FEDERAL FACILITY AGREEMENT AND CONSENT ORDER (FFACO)
RECORD OF TECHNICAL CHANGE (ROTC)

Corrective Action Unit (CAU) Number: 404

CAU Description: Roller Coaster Lagoons and Trench (TTR)

ROTC No. DOE/NV-11718-187 UC-702-ROTC 2 **Page** 1 **of** 8

CAU 404, CAS TA-03-001-TARC
Roller Coaster Lagoons
Administrative UR Boundary

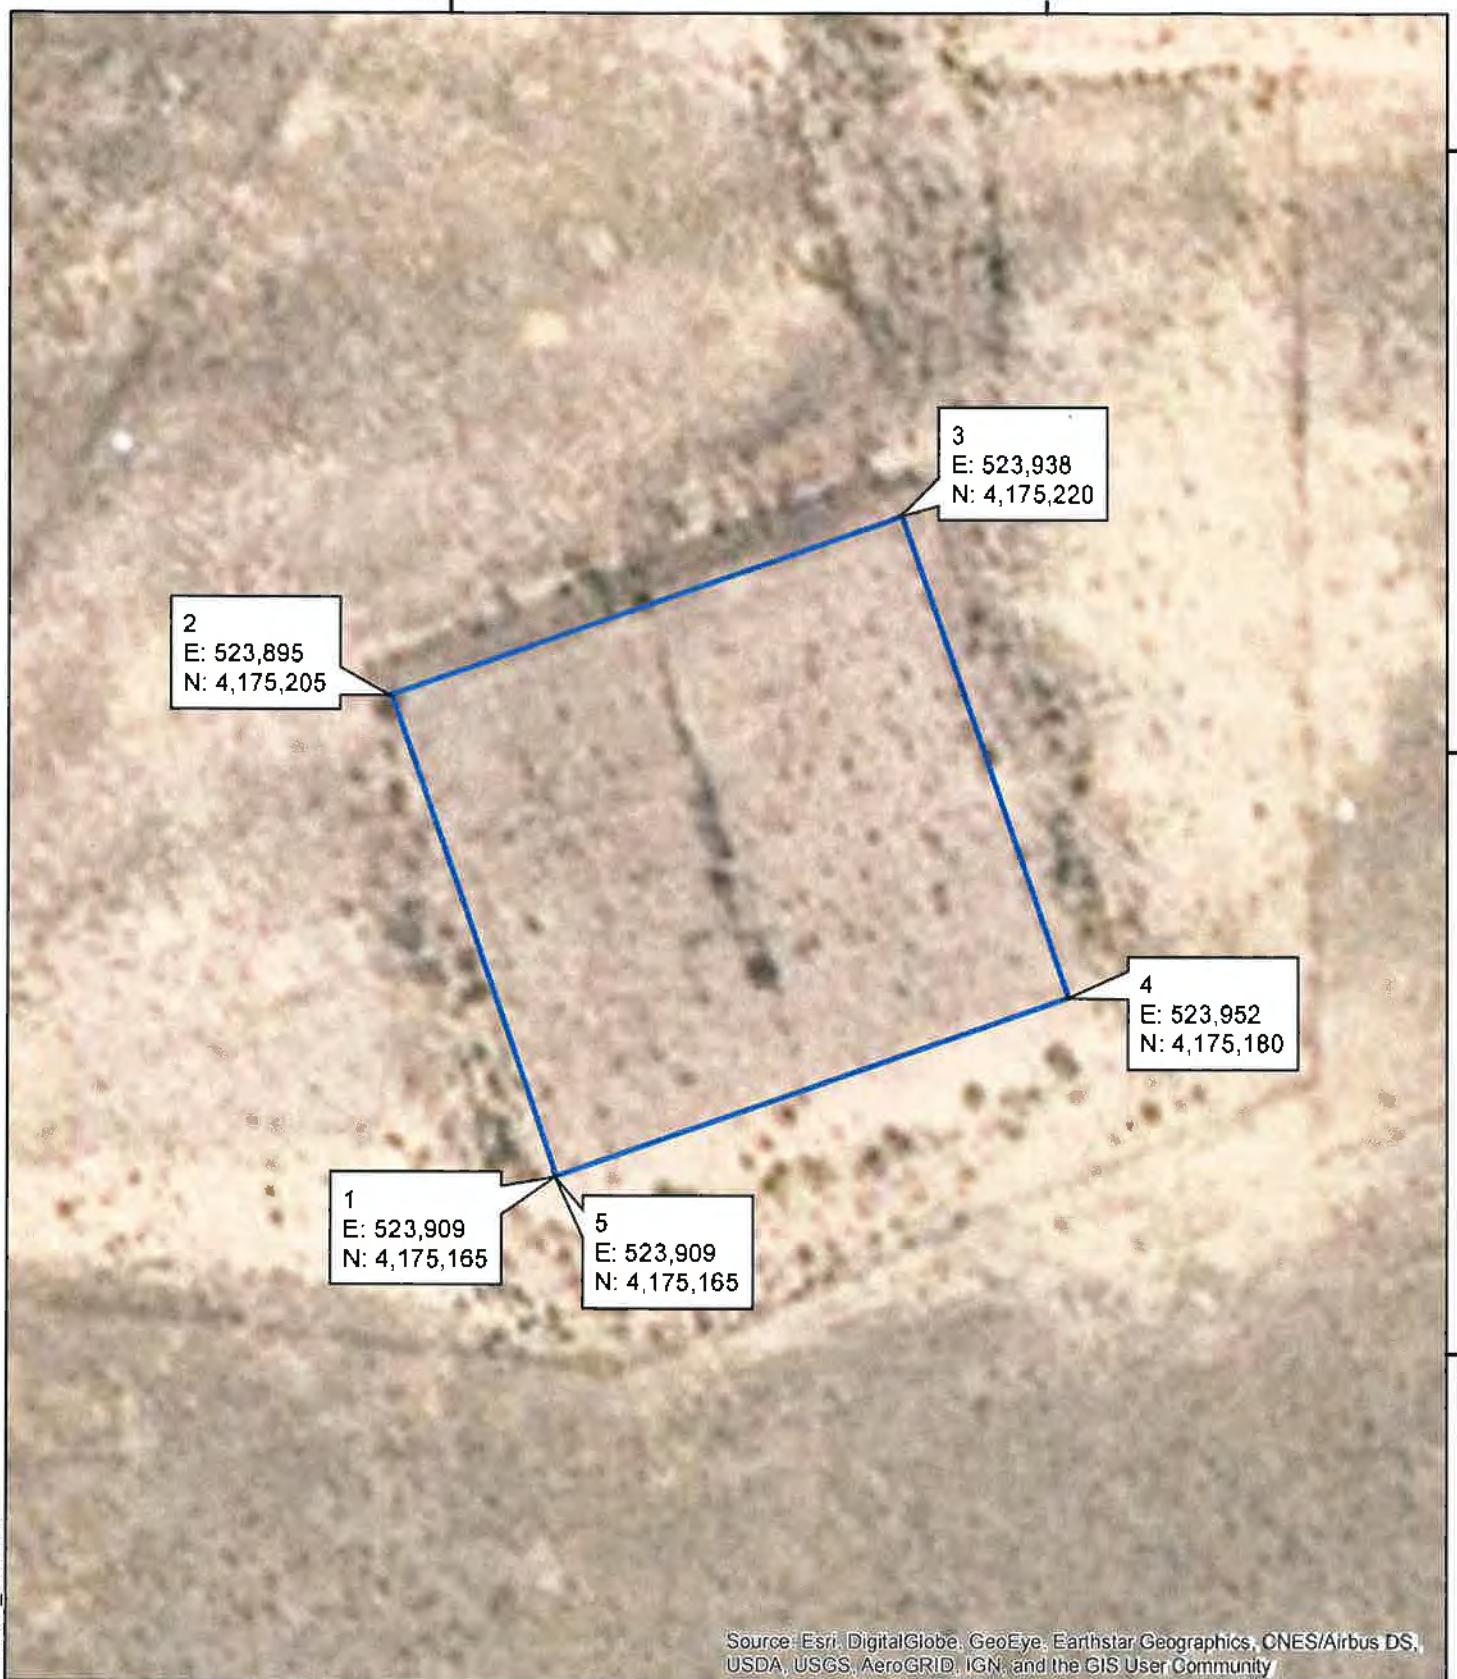
1. This ROTC replaces the Use Restriction (UR) information listed in the documentation for CAU 404.

UR forms have been updated to list all UR requirements, including but not limited to: post-closure site controls (signs, fencing, etc.), inspection and maintenance requirements, and Geographic Information Systems (GIS) coordinate information. The UR requirements and form(s) included in this ROTC represent the current corrective action requirements for each Corrective Action Site (CAS) in this CAU and supersede information concerning corrective action and post-closure requirements in existing documentation.

2. UR boundary coordinate values were changed due to conversion from North American Datum (NAD) 83 State Plane Central (m) to NAD 1983 for CAS TA-03-001-TARC.

UR Boundary	UR Point ¹	Easting ²	Northing ²
Admin Boundary	1	523,909	4,175,165
	2	523,895	4,175,205
	3	523,938	4,175,220
	4	523,952	4,175,180
	5	523,909	4,175,165

²UR coordinate values presented herein were transformed from the North American Datum of 1983 State Plane Nevada Central (meters), and rounded to the nearest meter; resultant coordinates may not reflect the original precision of values contained within the source GIS data set.
